GRA Consultation Response

STRATEGIC DEVELOPMENT FRAMEWORK SPD

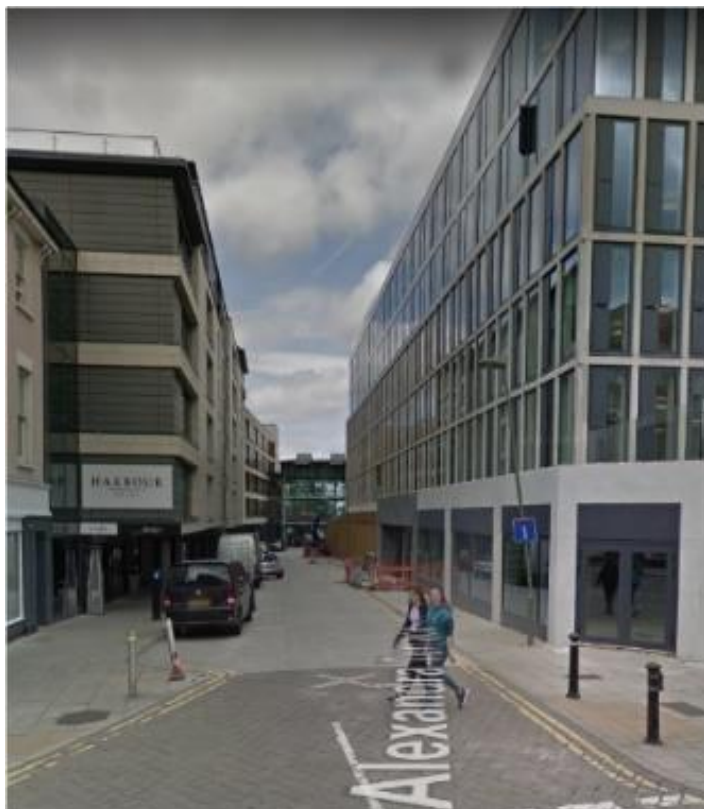
3.2.11 ADD: Understanding how local examples of this have led to good urban places **and whether traffic and parking have been issues** can inform placemaking.

Without a reference to traffic and parking, any suggestion historical patterns of development provide a model for future development is meaningless. Places with a finer grain of buildings and streets may be wonderful to live in or dysfunctional in terms of parking and congestion. Space for vehicles (be they electric or hydrogen, shared or individually owned, business vans etc) needs to be designed in from the outset. This was not done well at St Lukes and the site is dominated by on-street parking, pavement parking and cars overhanging drives. Some progress was made in providing less prominent car spaces on Boxgrove Gardens but provision is inadequate with many residents parking in neighbouring streets. Also, mothers with children find getting between their home and separated parking space in Boxgrove Gardens challenging.
